| STS-114 Flight Readiness Review | Presenter Alex Adams | |

STS-114 CoFR Endorsement

Independent Assessment Dissenting Opinion on T-O Umbilical Issue to STS-114 Flight Readiness Review

Independent Assessment Dissenting Opinion on T-O Umbilical Issue

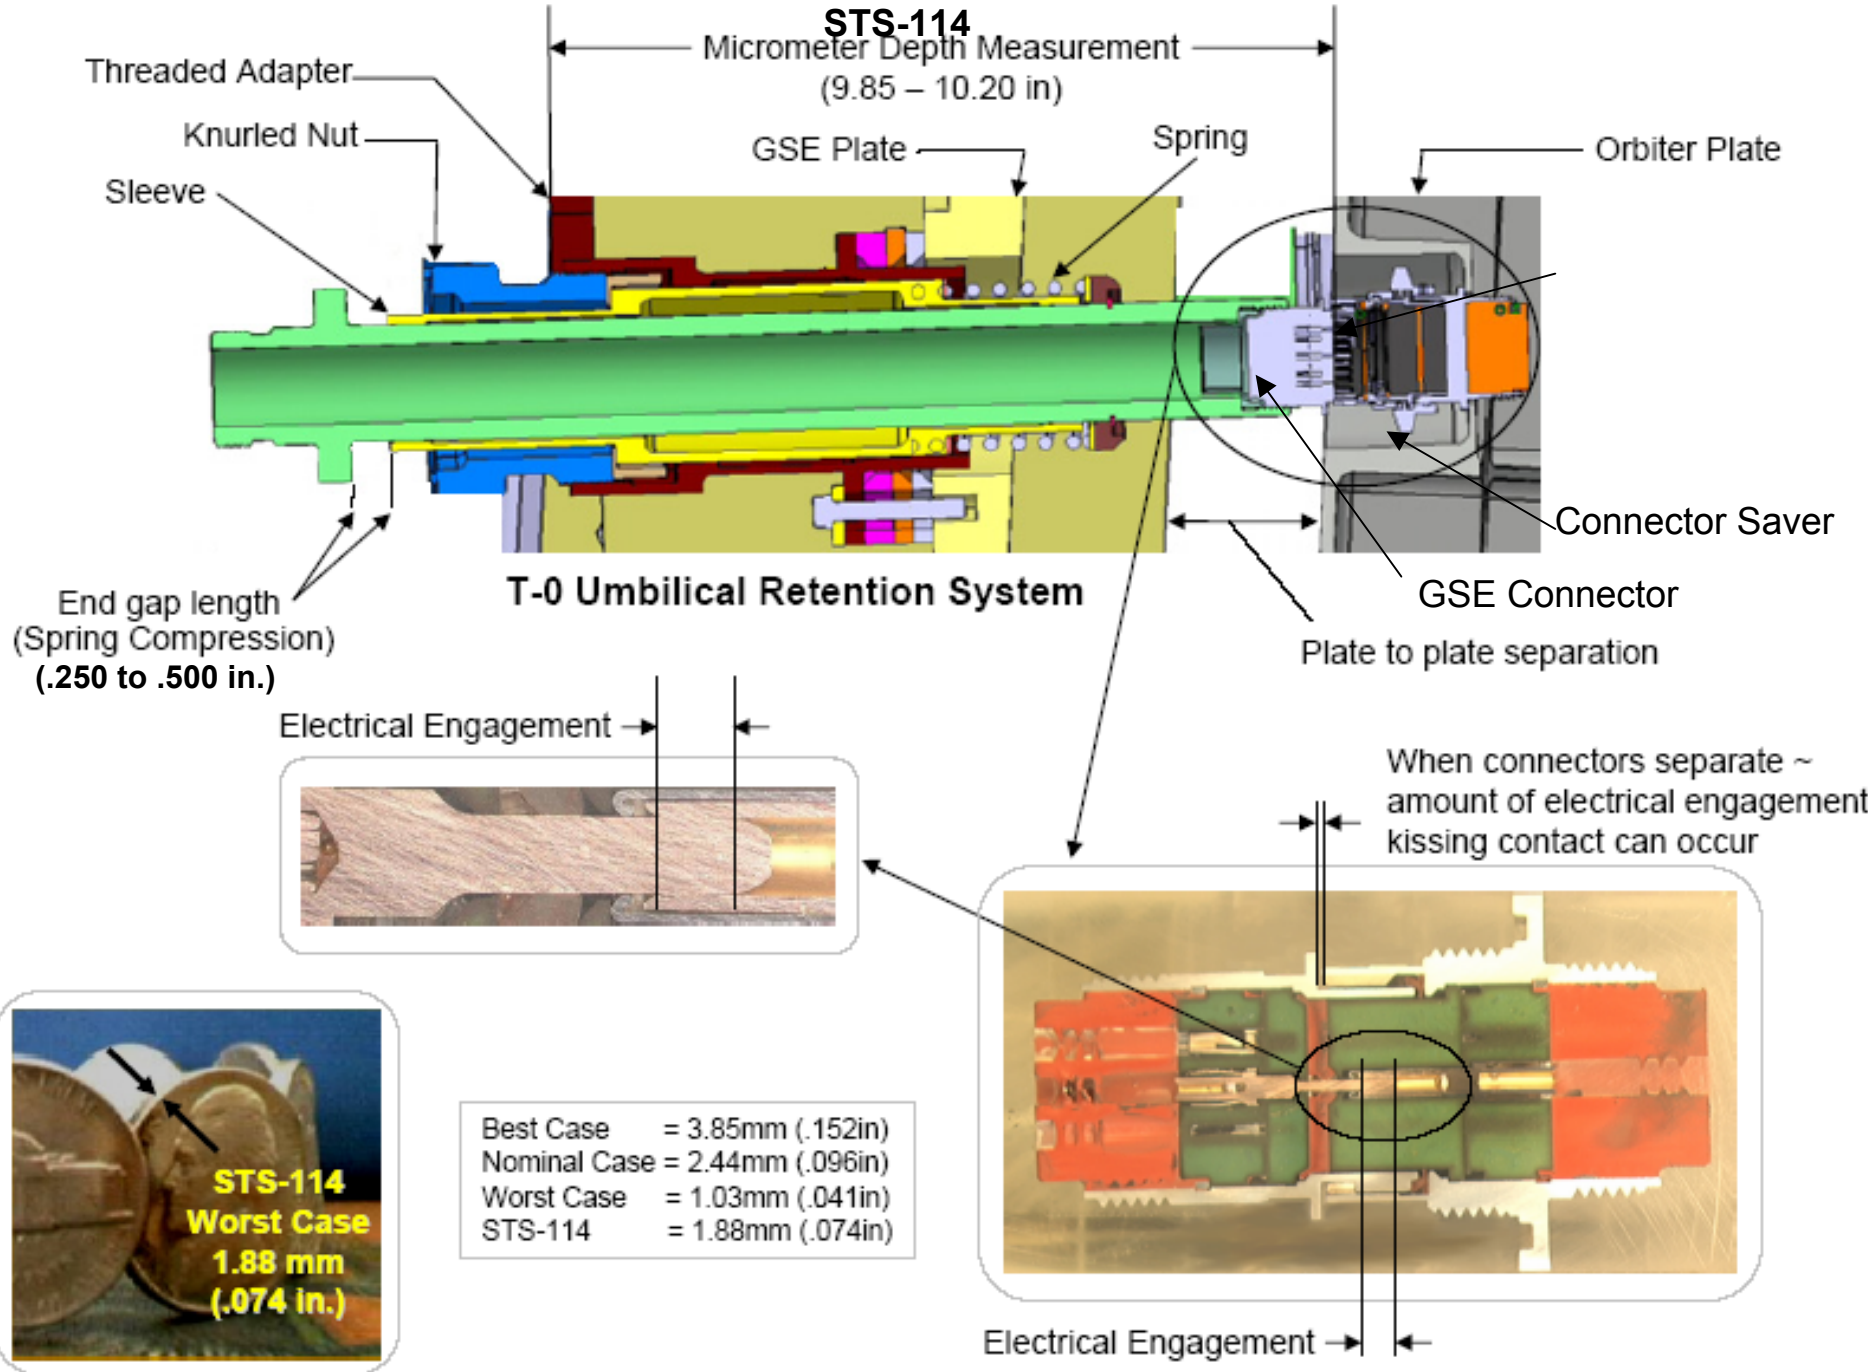
STS-112 Unexplained Anomaly – Space Shuttle Vehicle Release System A Fire 1 command failed to function at T-0. Previous Launch Anomalies: STS-105 LDB-1 lost during SSME start, STS-108 SRB LH Bus A erratic after SSME start, STS-110 SRB RH Bus A erratic after SSME start, and STS-111 SSME-3 EIU signal erratic at SSME start.

Catastrophic risk from the common cause failure resulting in inadvertent plate / pin / socket separation and loss of electrical continuity to the SRB Hold Down Post Pyrotechnic Initiator Controller Fire 1, Fire 2, and Return paths across the T-O Umbilical due to the dynamic vibro-acoustic environment from SSME startup through T-0.

- **ICD updates for ET Bellows heater**

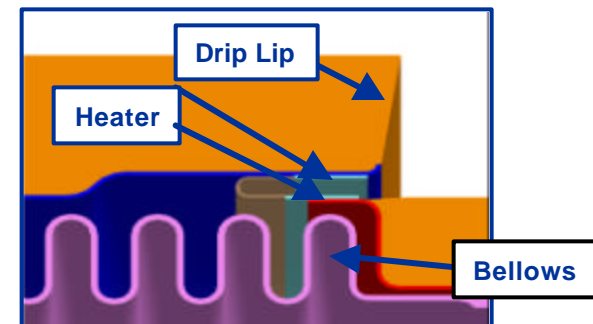
- Added a heater to eliminate ice at the LO2 Feedline bellows cavity
 - Lockheed Martin recommended the elimination of LO2 Feedline bellows ice for RTF
 - Originated by LM Ascent Debris Minimization Independent Review Team (ADMIRT)
 - Accepted by ET RTF project as part of baseline redesign activity
 - Three bellows locations addressed for RTF
 - SSP SE&I/ET Project telecon on 12/02/04 informally directed LMC to pursue heater option for Sta. 1106 (Only) and drip lip only for Sta. 1979 and Sta. 2026
